Roberts Road Quarry Modification 4

VENM / ENM Importation and Extension of Life
State Significant Development Modification Assessment
(DA 267-11-99 MOD 4)

Published by the NSW Department of Planning, Industry and Environment

Figure 5a | Proposed final landform Concept 1 (with 1,200,000 m³ fill)

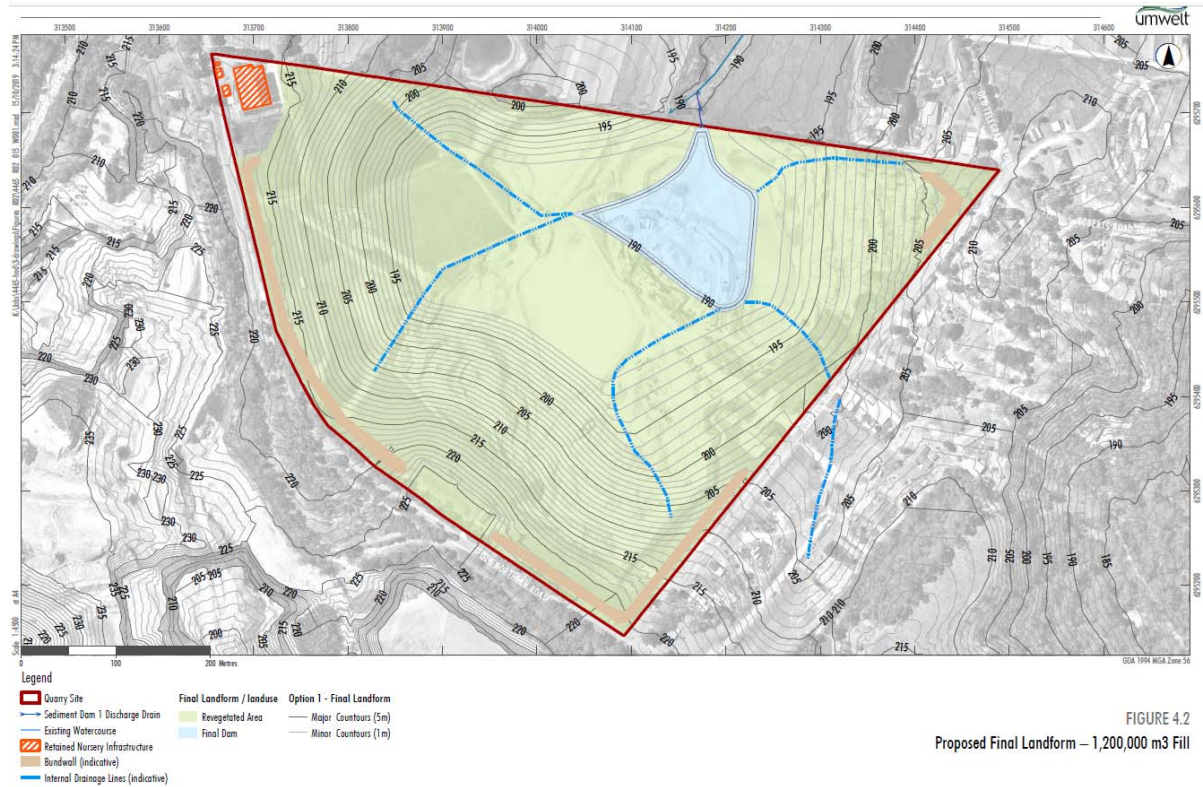
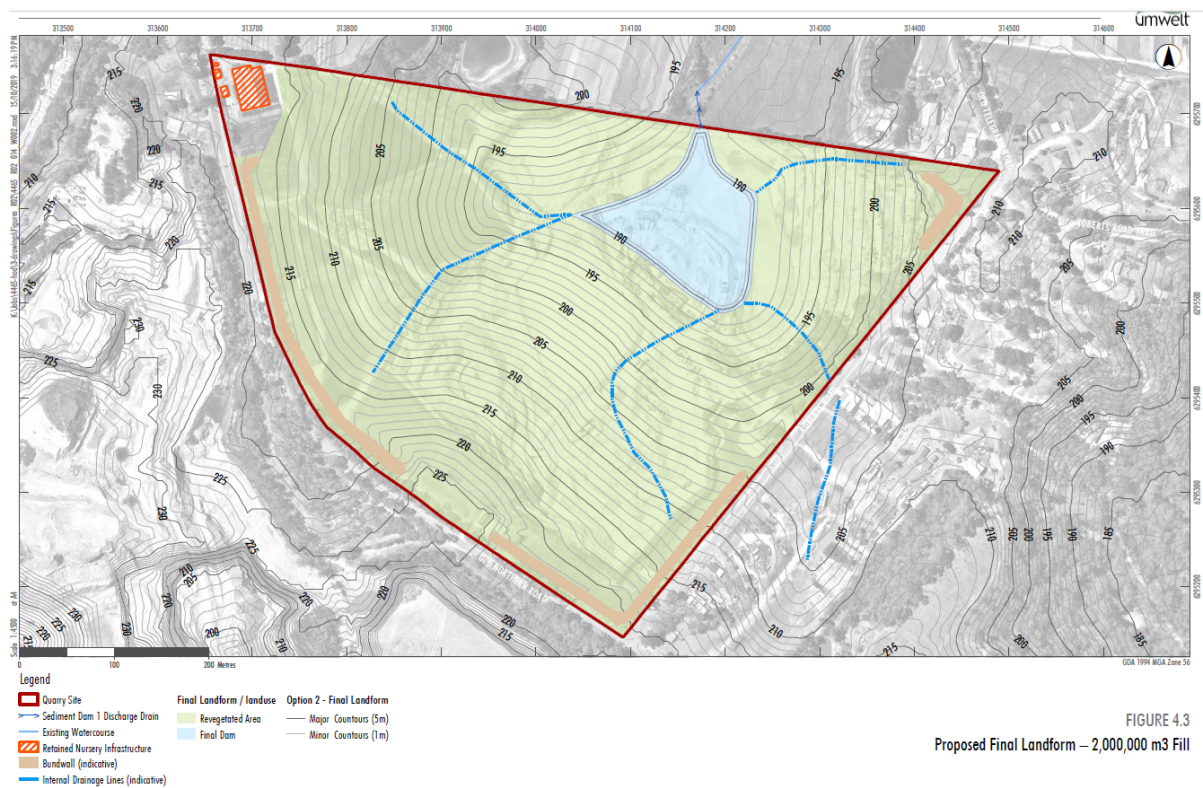
The existing approved final landform is shown in **Figure 4** and the proposed final landform options are shown in **Figure 5a** and **5b**. The Department acknowledges that the two proposed final landform options are considerably different to the current approved final landform. The approved final landform is characterised by short steep outer slopes contoured at 18 and 22 degrees and a generally flat pit floor draining to a large in-pit water storage that would not discharge from site.

The proposed final landform options are characterised by lower gradient slopes (between 8 and 11 degrees) and reduced pit floor footprints. They also include a free-draining basin that would discharge to

The Department has reviewed the two conceptual final landforms provided in the Modification Report and has compared them to the approved landform and considers both conceptual landforms would:

- be more consistent with the surrounding topography;
- achieve better integration of the site into the surrounding landform;
- be more resistant to erosion
- facilitate improved vegetation establishment;
- allow reinstatement of the drainage channels to mimic a more natural setting; and
- promote a more stable final landform by using VENM/ENM in combination with processing fines and topsoil for rehabilitation.

Given the above, the Department considers that either of the proposed final landforms options would improve project rehabilitation outcomes and HQP's ability to meet the rehabilitation objectives set out in the conditions of consent. Furthermore, the existing conditions of consent require HQP to develop and implement a Landscape and Rehabilitation Management Plan to detail the rehabilitation management, monitoring and maintenance requirements for the project in accordance with the conditions of consent. The Department is satisfied that the current Landscape and Rehabilitation Management Plan can be updated and implemented to facilitate successful rehabilitation of the Quarry site.
